# Access Compliance Report

## Public Rights-of-Way

### (Curb Ramps)

Intersection ID: 24242	Main Street: BEVERLY_CREST_BV	Cross Street: PRESCOTT_POND_LN	Location: E
ADA ID: 3498AC740C81	Ramp Type: PerpDiag	Initial Pass/Fail: Fail	Overall Compliance: No
		Severity Score: 37.5

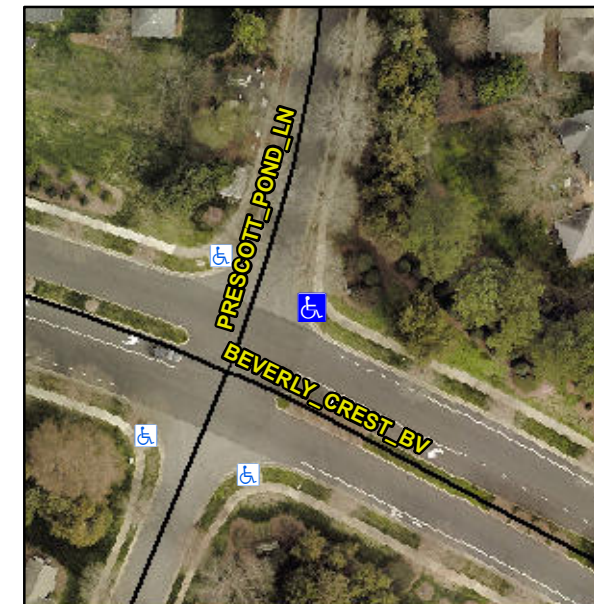
**Not Found, R304.2.2, R304.5.3**

Compliance	Description	Data	Compliance	Description	Data
N/A	Ramp Length (in)	95.0	No	Ramp Slope (%)	10.7
Yes	Ramp Width (in)	48.0	No	Ramp XSlope (%)	10.6
N/A	Flare Type LT	N/A	N/A	Flare Type RT	N/A
N/A	Flare Slope LT (%)	N/A	N/A	Flare Slope RT (%)	N/A
N/A	Flare Traversable LT?	N/A	N/A	Flare Traversable RT?	N/A
N/A	Landing Length (in)	N/A	N/A	DWS Provided?	N/A
N/A	Landing Width (in)	N/A	N/A	DWS Contrast?	N/A
N/A	Landing Slope (%)	N/A	N/A	DWS Length (in)	N/A
N/A	Landing X Slope (%)	N/A	N/A	DWS Full Width?	N/A
N/A	Landing Curb? (Y/N)	N/A	N/A	DWS Offset (in)	N/A
N/A	Shared Landing?	N/A			
N/A	Gutter Ponding?	N/A	N/A	Gutter Slope (%)	N/A
N/A	Gutter Lip Ht (in)	N/A	N/A	Gutter X Slope (%)	N/A
N/A	Painted X Walk1?	No	N/A	Painted X Walk2?	No
	X Walk 1 Direction	To NW		X Walk 2 Direction	To SW
N/A	X Walk 1 Width (in)	N/A	N/A	X Walk 2 Width (in)	N/A
	X Walk 1 Slope (%)	0.9		X Walk 2 Slope (%)	9.9
	X Walk 1 X Slope (%)	8.5		X Walk 2 X Slope (%)	6.7

**Remove & Replace Curb Ramp With Two New Directional Ramps or Equivalent.**
